**From:** Sonya Constantinou  
**Sent:** 19/09/2023 4:14:24 PM  
**To:** Thomas Prosser  
**Cc:** Council Northernbeaches Mailbox  
**Subject:** TRIMMED: Submission to DA2023/0976 at 20 - 22 Macpherson Street, Warriewood  
**Attachments:** Submission - DA2023-0976 - 20-22 Macpherson Street Warriewood.pdf;

**SUBMISSION TO DEVELOPMENT APPLICATION NO. DA2023/0976  
20 – 22 MACPHERSON STREET, WARRIEWOOD NSW 2102**

Figure 3: NBC Flood Hazard Map Risk. Subject site outlined in light blue.

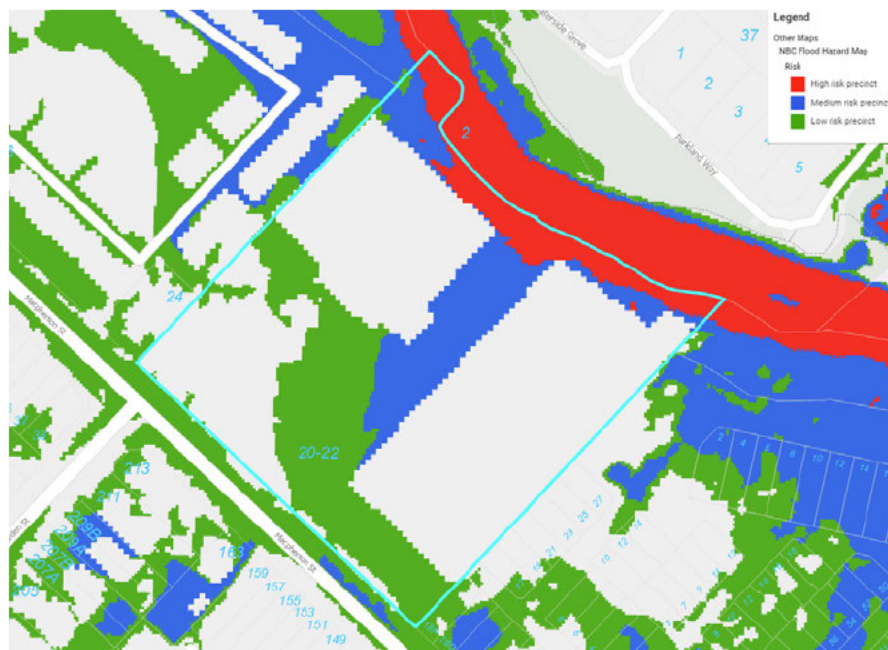
The site is identified on the NBC Flood Hazard Map as land of partly low, medium and high flood risk (refer to *Figure 3*).

A Flood Impact and Risk Assessment has been prepared to support the DA. The assessment provided has identified that the development complies with the 1% AEP, 1% AEP + 30% CC (climate change), PMF and PMF + 30%CC.

To enable compliance with these levels, substantial fill is required over the site. Specifically, at the western boundary of the site, Lot 60 will have an FFL of 10.71 and will likely require approximately 1.5m of fill located within 900mm of the boundary shared with 26 Macpherson Street. Similarly, Lot 41 is provided with an FFL of 10.71, and this will likely require approximately 2m of fill located 4m from the shared boundary.
